Planning application no. LCC/2014/0101

by Cuadrilla Bowland Limited to drill at

Roseacre Wood, Lancashire:

Objection on grounds of geology and hydrogeology

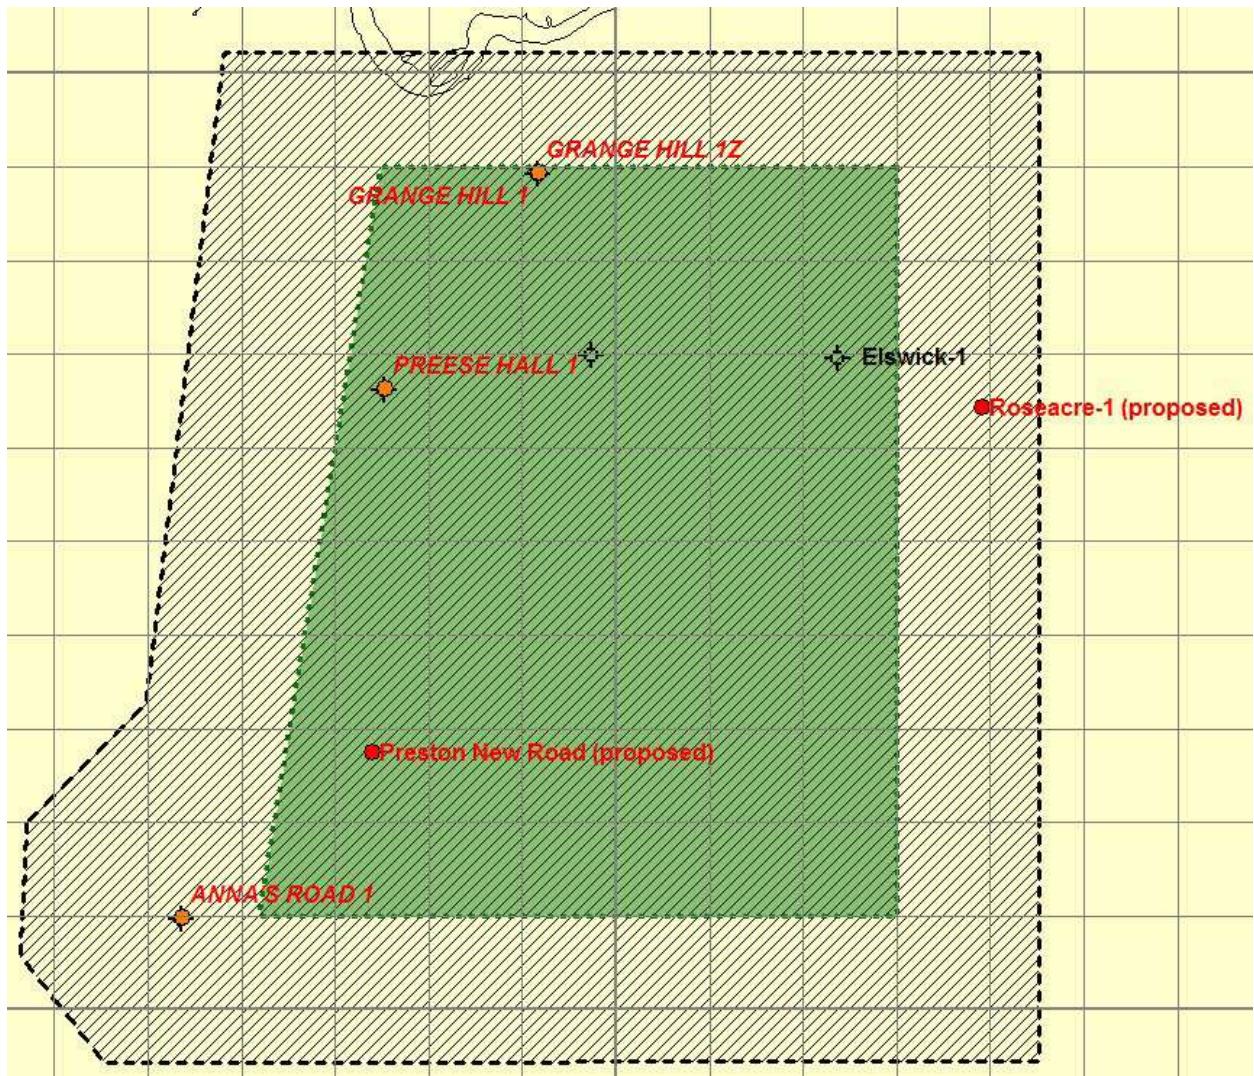
Figure 2.1 shows the surface extent of the sources and receivers used in the 3D survey (diagonal hatching). But only within the area coloured green is the survey at its full fold, and therefore capable (in principle) of imaging all the structure below. Outside of this area, the data quality diminishes progressively from a possible 60-fold at the edge of the green area to 1-fold at the edge. So the 3D image below the proposed drillsite will be of poor quality.

In order to clarify these deficiencies the applicant should supply for the seismic dataset and its interpretation:

1. The acquisition and the processing reports.
2. Numerous examples of seismic cross-sections through the 3D volume, in triplets comprising raw pre-stacked time, raw depth-converted and depth-converted with superimposed interpretation; around five E-W images and five N-S images should suffice, passing through existing wells.

3. These cross-sections should be accompanied by a graph above or below showing the fold (multiplicity) of coverage, as an indication of data quality.
4. Examples of well-tie to seismic *via* velocity and/or VSP logs should be shown, both for wells within the 3D area and, using 2D seismic, for other wells within the licence area.
5. The 'independent' interpretation review report carried out by Arup/DMT.

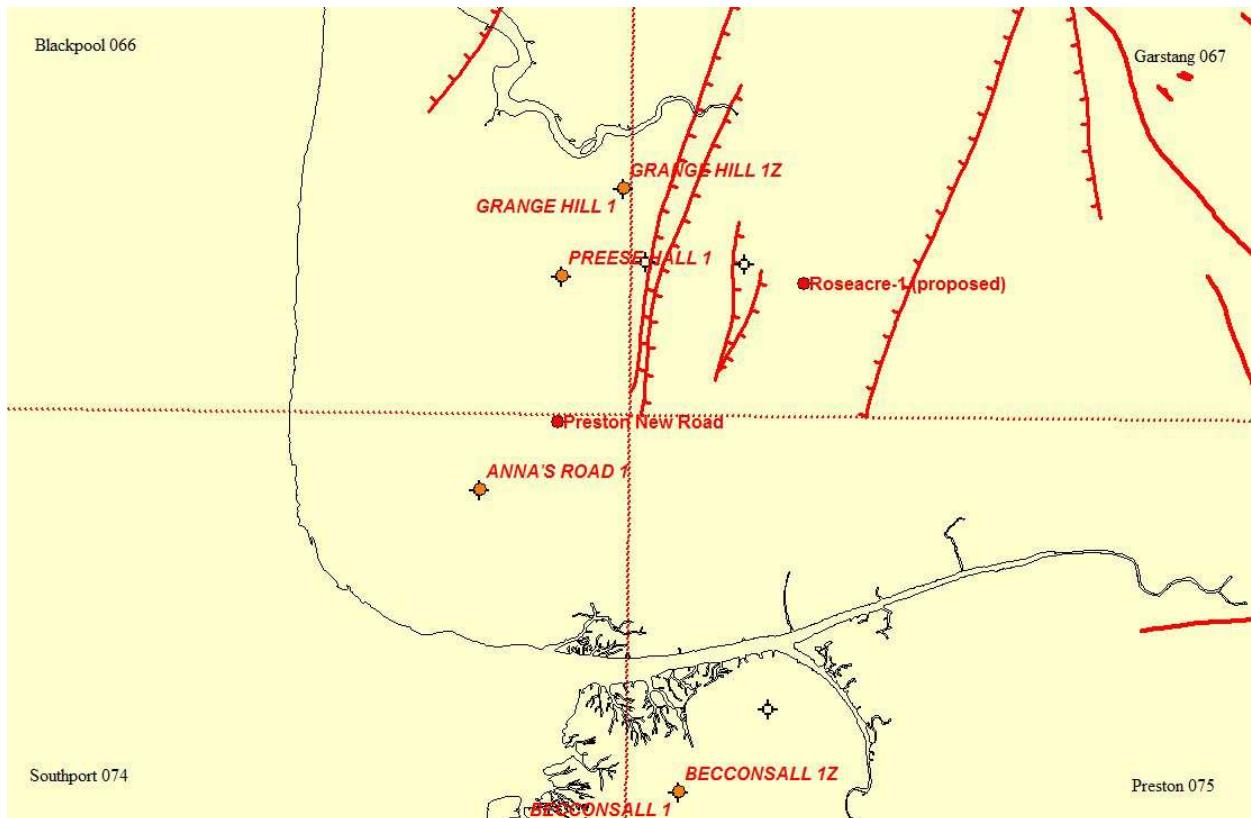
Thus in Figure K3 (Hydrogeology, appendix K), as an example of the first dependency above; two parallel faults, one of which is labelled the Thistleton Fault, are shown on the published BGS solid geology maps as dying out in the centre of the picture about 6 km SW of the Roseacre site. The faults are shown in Figure 3.1 herein. But this is not because they actually die out, as Cuadrilla's own interpretation of its 3D results shows. The apparent termination of the faults at the western and southern edges of the Garstang 1:50,000 sheet 67 (published in 1990) is an inconsistency due to the fact that the three adjacent sheets were mapped at different epochs (Fig. 3.1). The intersection of the four sheets is 5.7 km SW of the proposed drillsite. That is why the faults apparently die out to the south. In fact the newest mapping is of the Preston sheet 75 (published in 2012), which shows major faults, but these faults have not yet been added to the BGS digital database used by Cuadrilla and by myself. That is why I have cross-checked the BGS digital database with the paper printed maps, something which Cuadrilla evidently has not done.

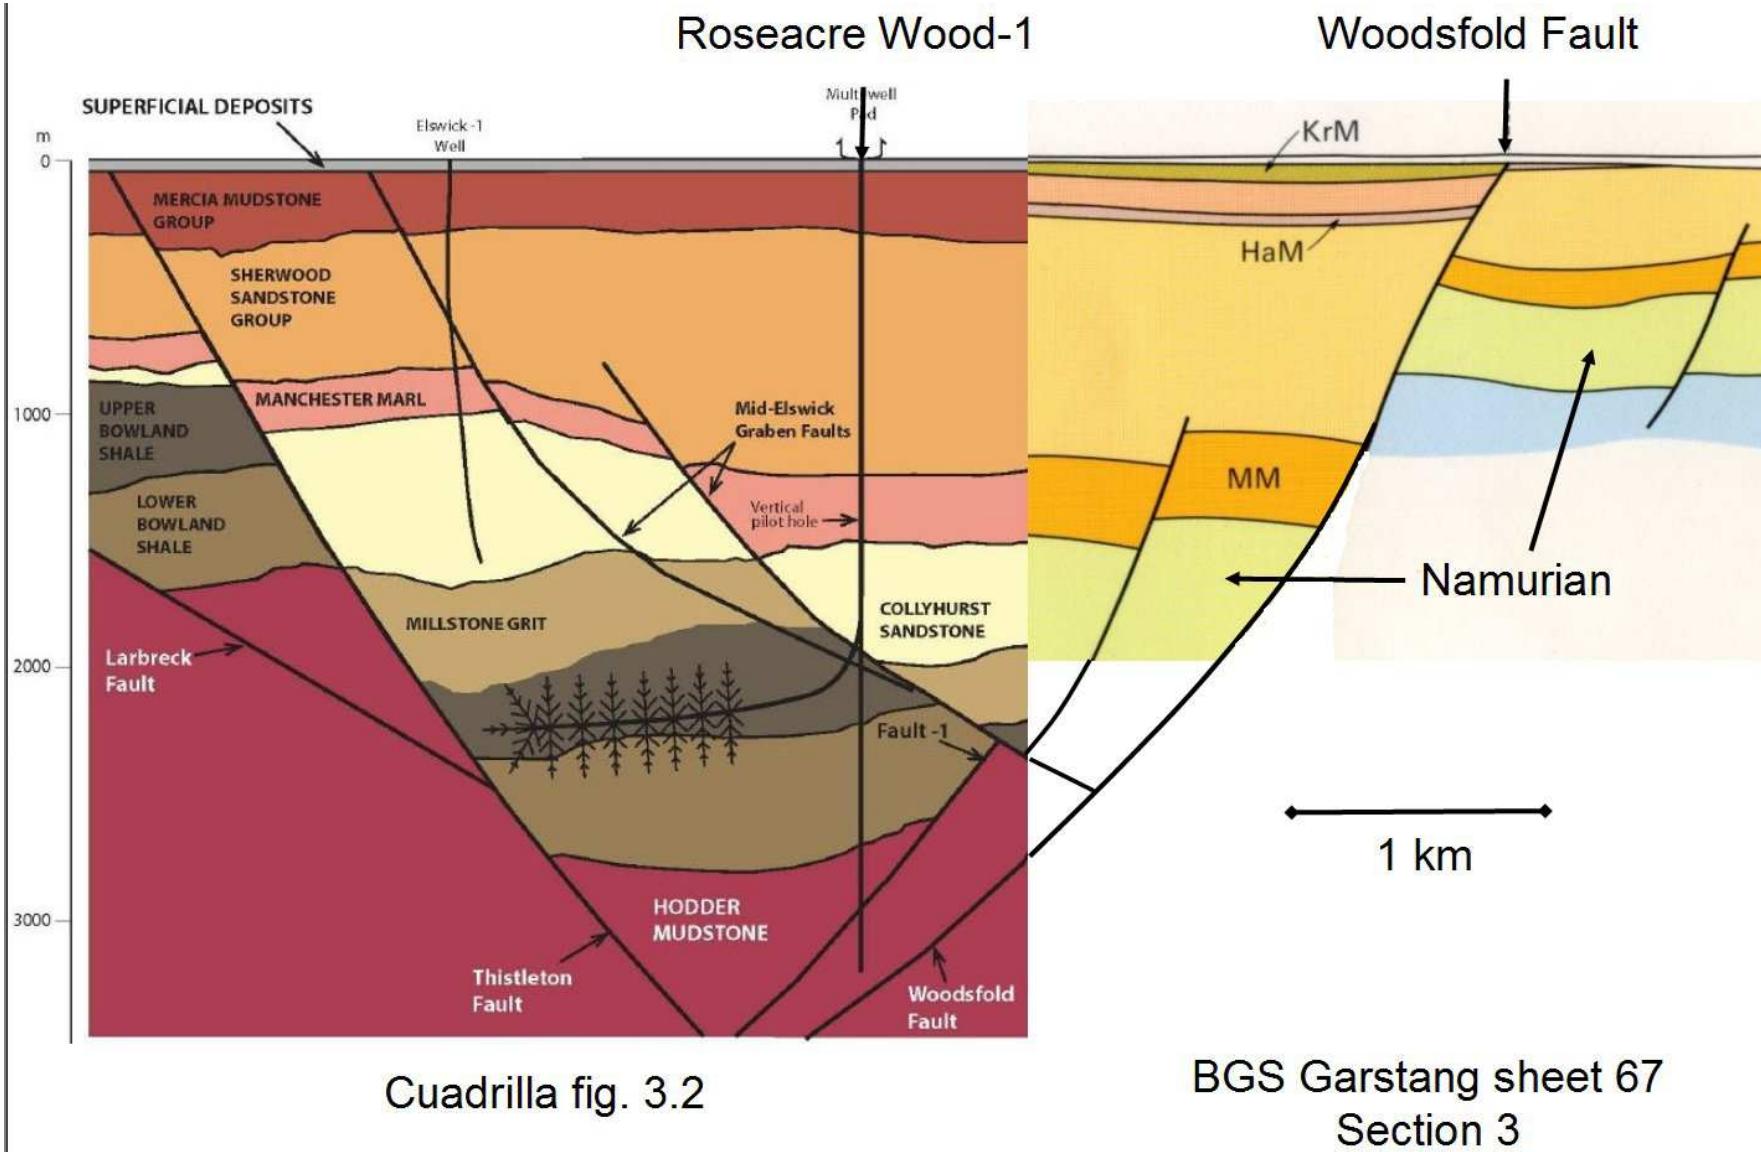
Fig. 3.2 shows the Cuadrilla cross-section through the proposed well (ES vol. 1 p. 23, fig. 3.2) combined with cross-section 3 from BGS Garstang sheet 67. The former is 3.6 km long, and there is a gap of 300 m between the right-hand end of this section and the nearest point of the BGS section. The BGS section, dating from 1990, is out of date in places. On the BGS section the Mercia Mudstone Group is subdivided into three layers, and is shown as slightly thinner than on the Cuadrilla version. There is a good match of the Manchester Marls (MM), but the BGS section shows Namurian (Upper Carboniferous) immediately below, with no Permian Collyhurst Sandstone. This error is because the BGS section was compiled before the existence of the Elswick-1 well which proved at least 500 m of Collyhurst Sandstone, as seen on the Cuadrilla side of the combined diagram. Presumably the Collyhurst Sandstone runs east to the Woodsfold Fault, where it is upfaulted to the east; the 'Namurian' (light green) labelling of the BGS part of the combined cross-section should be disregarded.

I have interpolated the Woodsfold Fault between the two cross-sections, and have continued the 'Mid Elswick Graben' faults as one single fault going deeper to the east to terminate against the Woodsfold Fault. All the faults appear to be post-early Sherwood Sandstone in age,

and the bigger ones are post-Mercia Mudstone Group in age. Cuadrilla's interpretation implies that the Thistleton Fault was a growth fault active during Collyhurst Sandstone deposition, to account for the vastly greater thickness of this rock group on the downthrown side. On the other hand, the more easterly of the 'Mid Elswick Graben' faults seems to be post-Collyhurst in age, but acted as a growth fault during Manchester Marls time.

The cross-section looks like it could not be 'balanced'. This means that it has internal inconsistencies, such as thicknesses of rock groups varying or disappearing without reasonable explanation. Only the westernmost two-thirds of the Cuadrilla segment of the cross-section, starting from about half-way between the Elswick-1 well and the proposed Roseacre well, is within the 3D 'full-fold' zone, as described in section 2.2 above. This casts further doubt on the reliability of the geological interpretation.

Doubts such as this about the validity of Cuadrilla's mapping, even when 3D seismic data has been used, make it crucial that examples of the 3D seismic data and its interpretation be provided for independent scrutiny.

Fig. 5.1. Schematic geological cross-section (Environment Agency 2006), to which labels and arrows in red and blue have been added, showing hydrogeological characteristics across the Woodsfold Fault. Red indicates fresh water, blue saline.

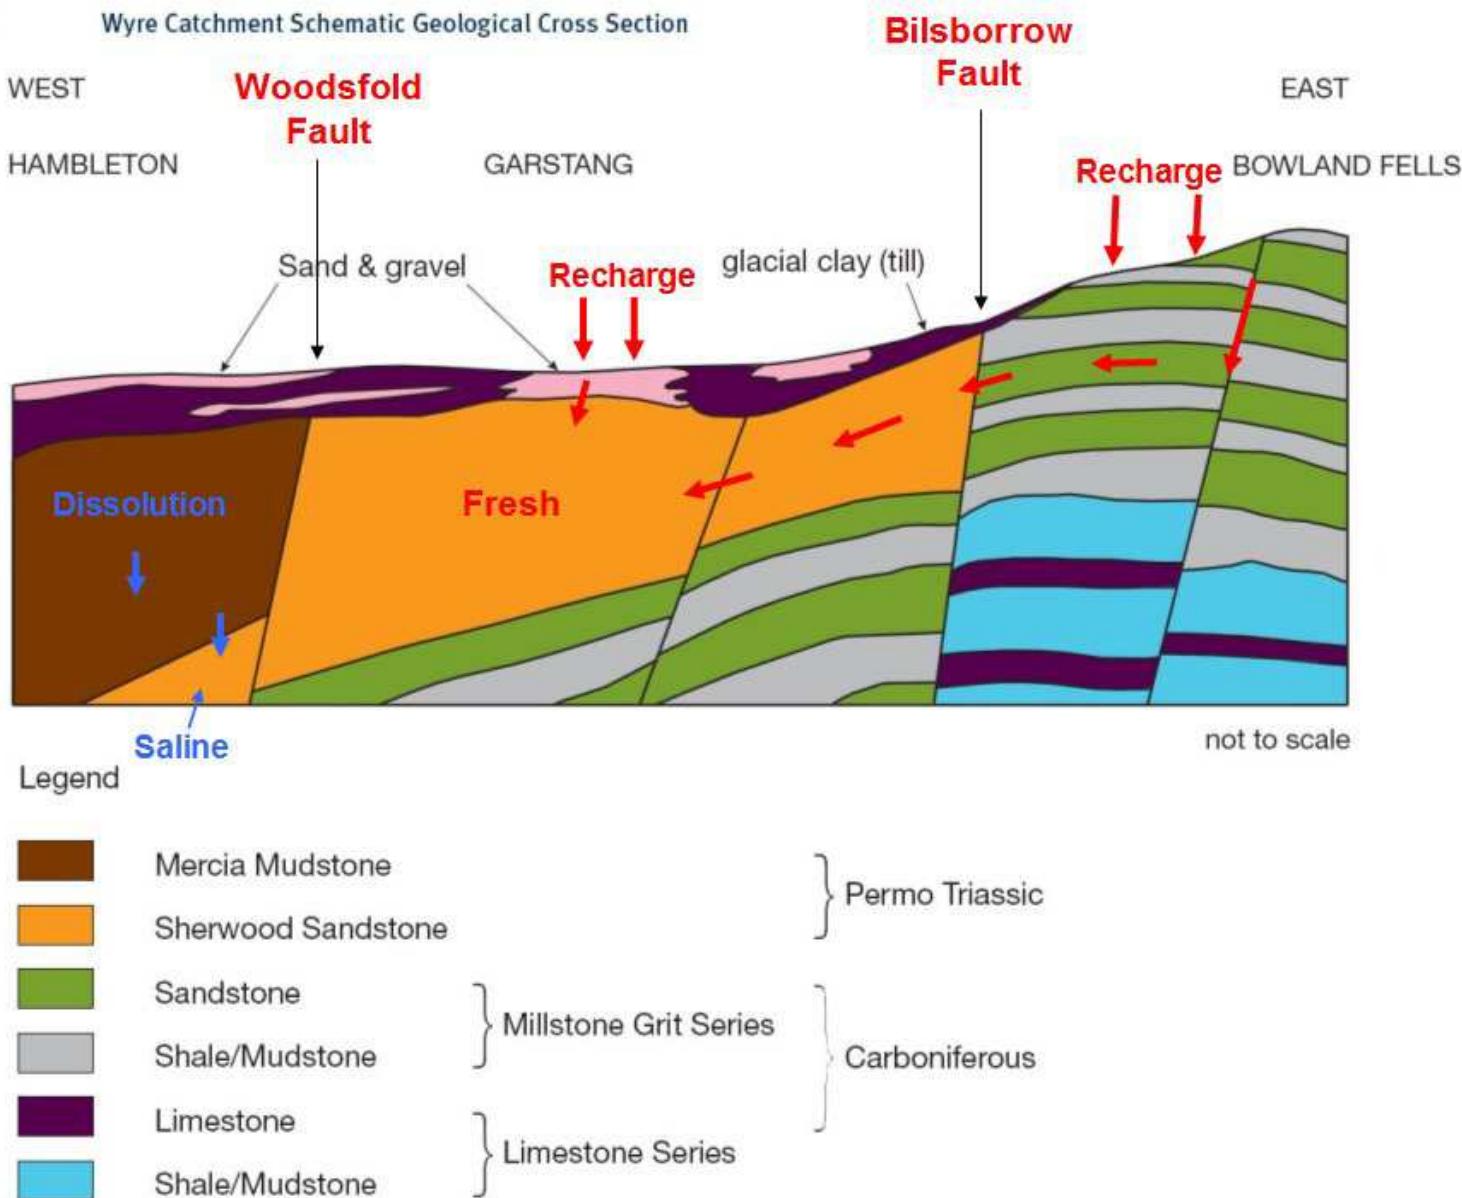
We can now synthesize the information of the two preceding sections. Figure 5.1 is a schematic cross-section (Environment Agency 2006) of the area east of the current application site. I have added labels, and arrows to indicate water flow. Recharge of the important SSG

aquifer (orange in the centre of the cross-section) occurs both by downward filtration through the Quaternary sand and gravel, and also through the Millstone Grit Series of the Bowland Fells across the Bilsborrow Fault. The red arrows show fresh water transport directions.

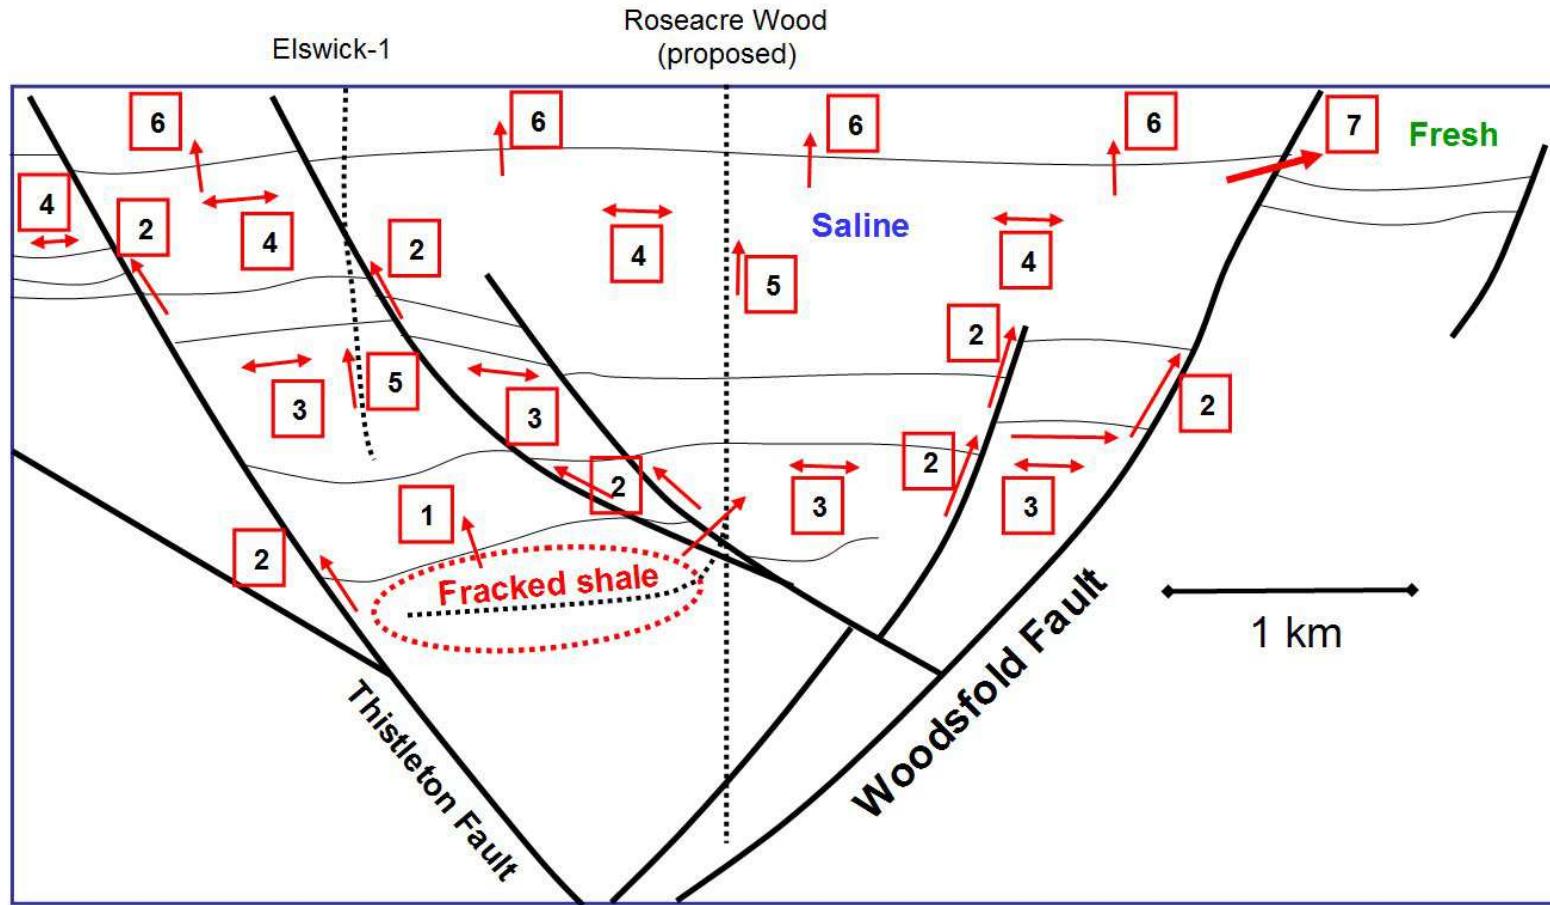
Figure 5.2 shows a line-drawing outline of the combined Cuadrilla/BGS geological cross-section through the proposed well, from Figure 3.2. Well tracks are shown as dotted lines. Faults are shown as bold solid lines, and geological boundaries as light solid lines. Numbers in red rectangles beside each arrow refer to likely fluid flow paths (with double-headed arrows indicating vigorous flow possible within a highly permeable layer):

More crucially, the Manchester Marls are only 270 m thick at the well (ES vol. 1, table 11.6, p. 298), and about half that thickness further west. This layer will not, therefore, provide a viable cap-rock. In any case, flow paths 1 and 2 (Fig. 5.2) permit rapid migration along the highly permeable Collyhurst Sandstone below. The drillsite pad is only 2.6 km from the outcrop of the Woodsfold Fault, which, I have argued, will be transmissive. Below ground **the drill hole is only about 1500 m horizontally away from the fault.**

1. Directly upwards from the Upper Bowland Shale into the permeable Millstone Grit Group.
2. Up the transmissive fracture zones of faults.
3. Along the highly permeable Collyhurst Sandstone, only partially confined by the Manchester Marls.
4. Flow within the Sherwood Sandstone Group.
5. Flow up leaking wells.
6. Directly upwards from all the preceding sources through the Permian and superficial deposits to the surface.
7. Flow across the Woodsfold Fault from the downtown saline block (blue) into the Principal Aquifer of fresh water (green).
